Clarksburg Village

MEMORANDUM

Initial Hearing Regarding Alleged Violations

Site Plans 820030020 (Formerly 8-03002) and 82003020A (Formerly

Lot Sizes

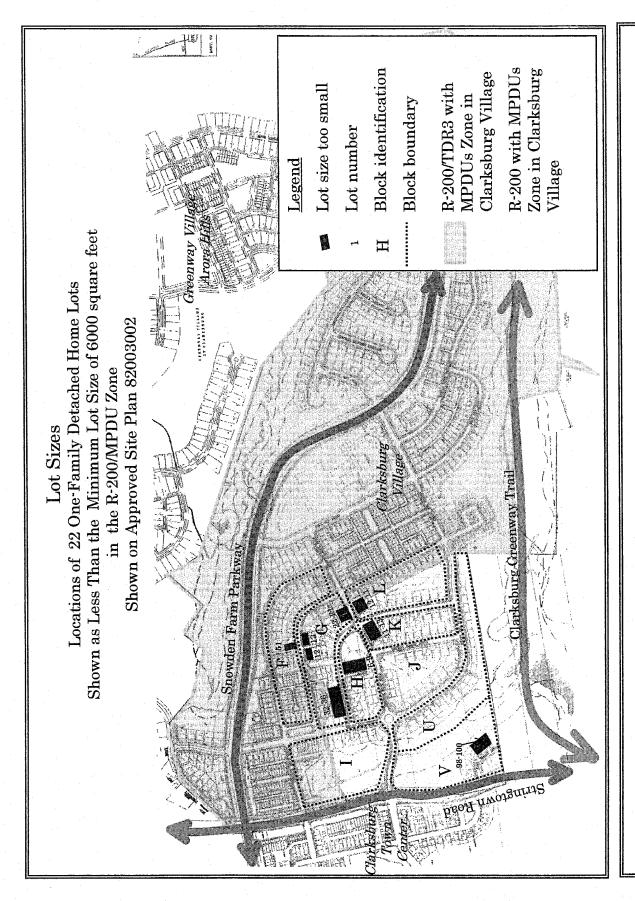
in Violation of Required 6000 square foot minimum lot size in the R-200/MPDU Zone Photographs of Examples of Lots for One-Family Detached Homes

Lot 21G 4000 square feet 5000 square feet Lot 22 G

Lot 12G 5500 square feet

Lot 13K 5663 square feet

5960 square feet 4200 square feet Lot 12 L Lot 11L

Setbacks

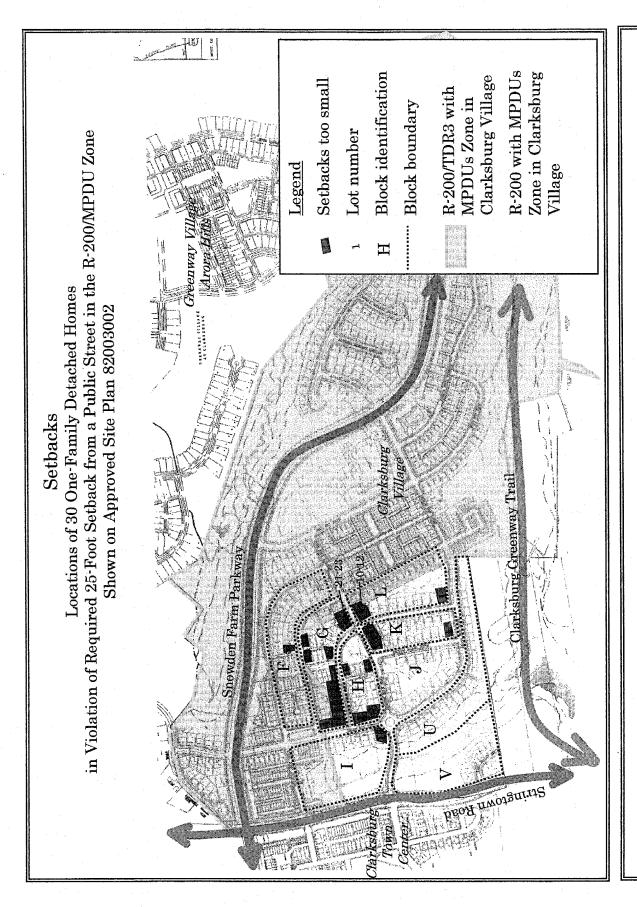
in Violation of Required 25-Foot Setback from a Public Street in the R-200/MPDU Zone Photographs of Examples of One-Family Detached Homes

Lot 23G 20-foot side setback

15-foot side setback Lot 26G

Lot 37G 15-foot side setback

Lot 13K 15-foot side setback

21.5- foot front setback

15-foot side setback Lot 1H
